Re: Montague Wind Energy Facility Change Order Request #2 (O&M Building)

RE: Request for Determination Pursuant to OAR 345-027-0050(5) for Proposed Change to Montague Wind Power Facility – Change Request #2 (O&M Building)

Attachment 1: Staff Evaluation of Change Request No. 2 and Determination

**Proposed Fiber Connection from
Monague to Leaning Juniper IIb
Montague Wind Project**

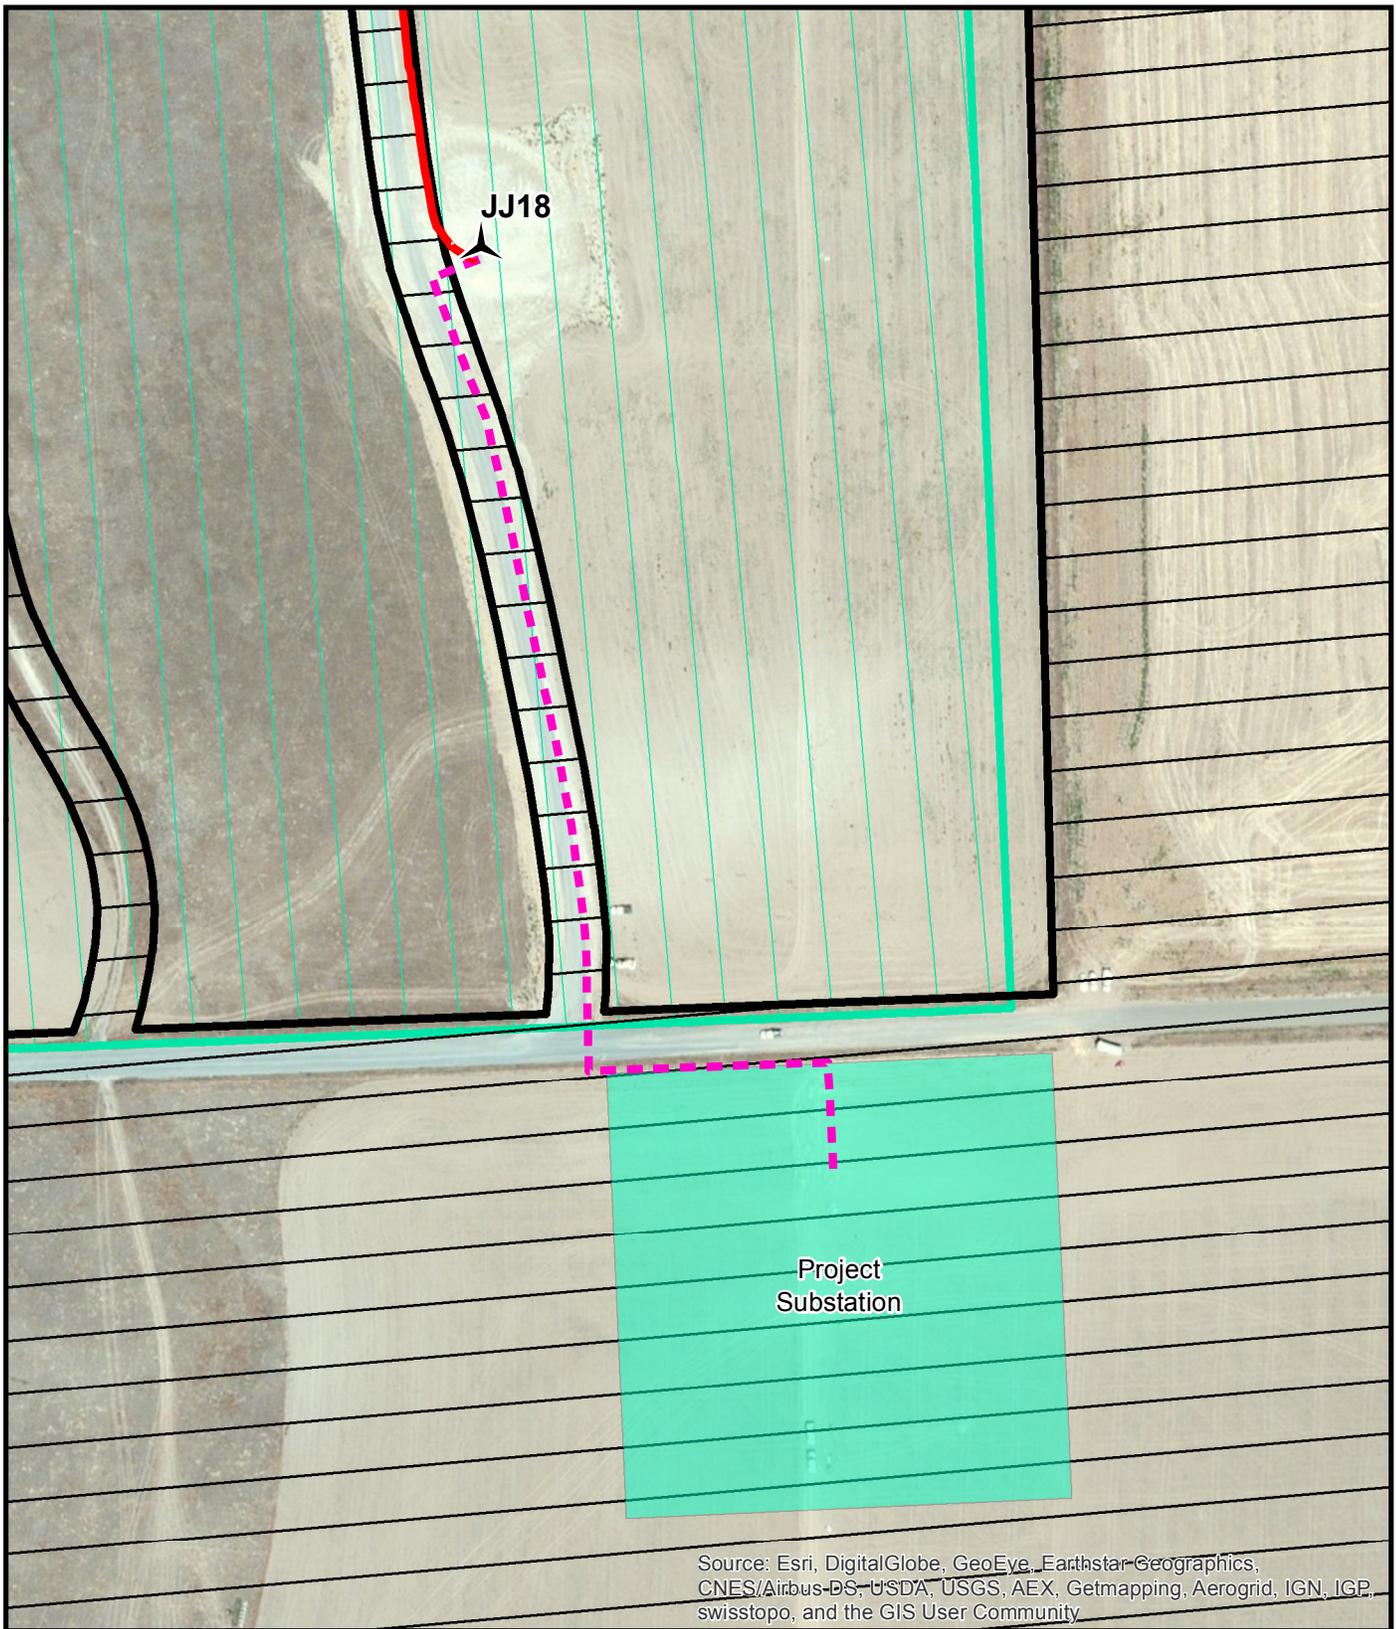
The Facility is adjacent to LJIIB, and in some places, the projects have overlapping site boundaries. See [Attachment 1](#) (Project Figure). Certificate Holder proposes to interconnect Montague fiber with LJIIB's existing fiber and 34.5 kV collector line at Turbine JJ18 within both the LJIIB and Montague site boundaries. From there, Montague and LJIIB operational data would transfer over the existing installed fiberoptic lines that return to the LJIIB O&M building. Attachment 1 shows the relationship between the Montague and LJIIB site boundaries and the proposed design modification. If approved, Certificate Holder would enter into a shared facilities agreement with LJIIB, LLC to share the O&M building and associated equipment. No improvements, with the exception of additional communications equipment within the O&M building are proposed. No construction would occur outside of the Montague site boundary. By sharing the LJIIB O&M building, Certificate Holder minimizes permanent impacts and avoids construction of an on-site well and septic system at Montague.

The Department requests that Montague provide an updated site boundary map for the Montague Facility to show the minor site boundary expansion. Please also provide the Department with updated GIS data corresponding to the updated site boundary.
